**TO:** HEARINGS OFFICER

**SUBJECT:** **CONDITIONAL USE / CLASS 3 SITE PLAN REVIEW / CLASS 2  
DRIVEWAY APPROACH PERMIT / CLASS 1 DESIGN REVIEW CASE  
NO. CU-SPR-DAP-DR20-06  
5600 BLOCK OF WOODSIDE DRIVE SE - 97306  
AMANDA NO. 20-110657-ZO, 20-110687-RP, 20-110692-ZO, & 20-  
110689-DR**

Summary: Development of a new two building apartment complex with 24 dwelling units.

# SITE PLAN

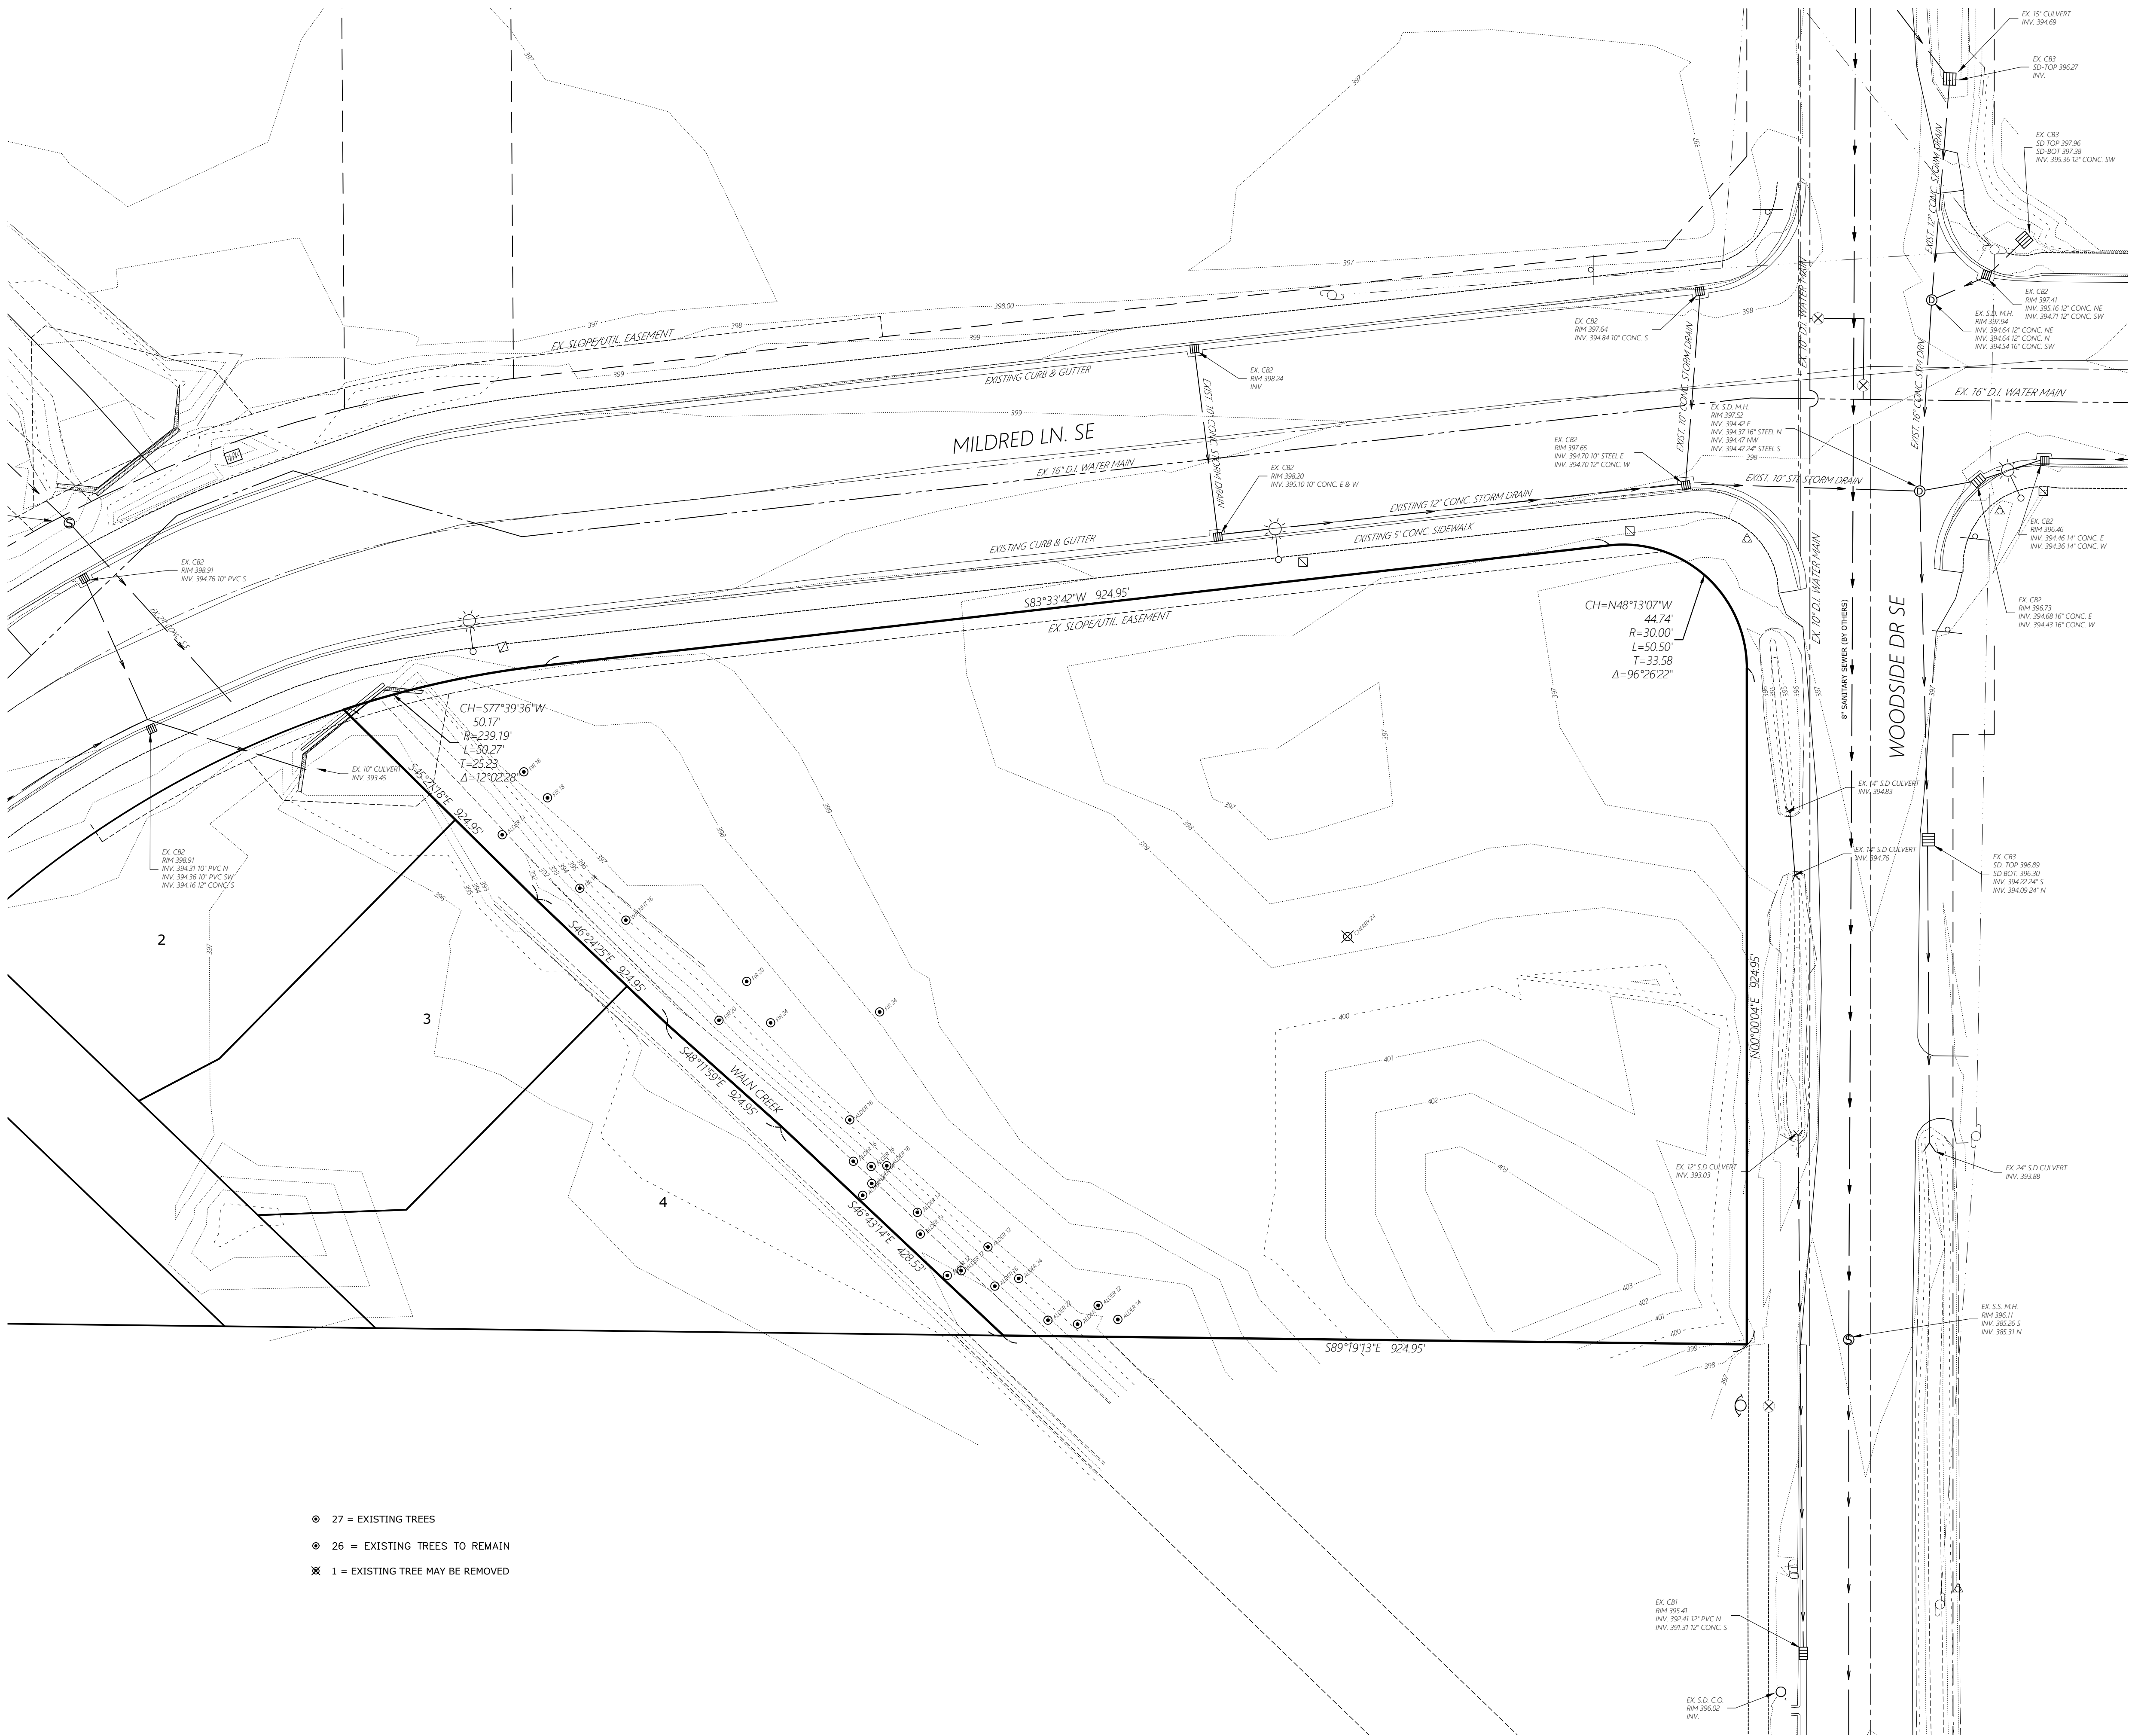
**Finding:** The proposed site plan indicates that the enclosure walls will be cmu block. A bumper curb 12 inches inside the perimeter of the enclosure walls is required, however the curb is not indicated on the proposed plans.

**Finding:** The applicant's proposed site plan does not match the proposed landscape plan. The proposed landscape plan eliminates one off-street parking space from the site plan, and in its place is a landscape island required by SRC Chapter 702.

**Condition 5:** Prior to building permit issuance, the proposed site plan shall be updated to include the additional landscape island shown on the landscape plans.
